MVP Variance Request Form

Variance Request

A-40

**Mountain Valley Pipeline, LLC
Mountain Valley Pipeline Project
Docket No. CP16-10-000**

Mountain Valley Pipeline Variance Survey Exhibit; Variance A-40

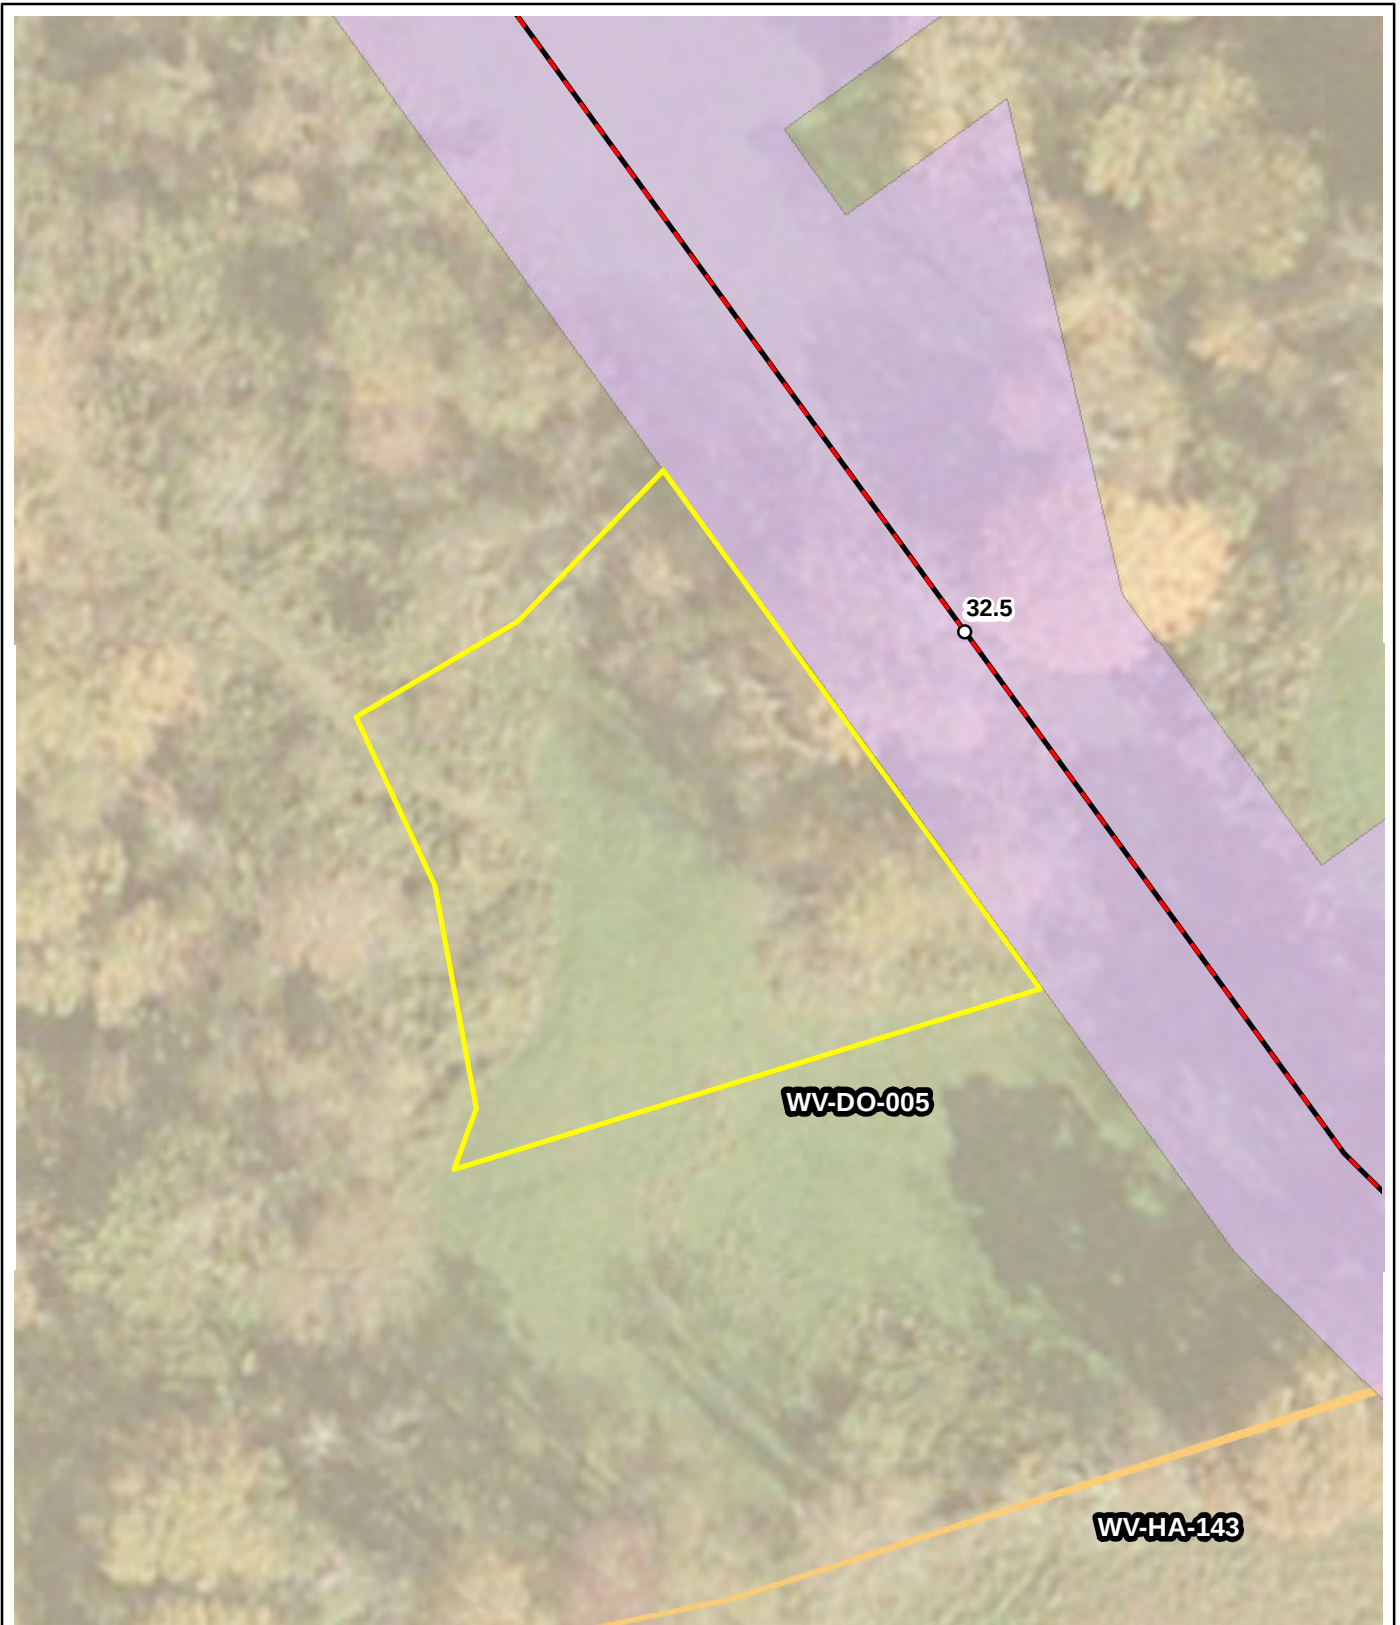
The modification of the tree clearing results in a net increase of 0.02 acres MYSO - Unknown Use Summer Habitat (UUSH). Tree clearing will not occur between June 1st - July 31st and October 1st - November 14th as per the BO. On January 29, 2018 the USFWS concurred with MVP's proposed process for reviewing variances that require tree clearing. Attachment 2 includes a table that shows MVP's acreage "banks" will remain net positive following approval of this variance request.

On 04/07/2016, and 08/24/2016, Environmental Solutions and Innovations, Inc. (ESI) conducted field surveys to search for portal openings (winter bat habitat). Surveys were conducted in accordance with agency approved protocols for the project. No portal openings were observed in the variance area.

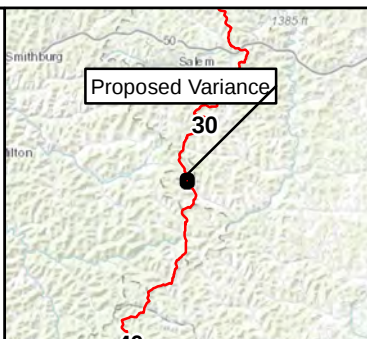
During field surveys, Tetra Tech did not identify any wetlands or streams in the variance area as shown on the attached figure.
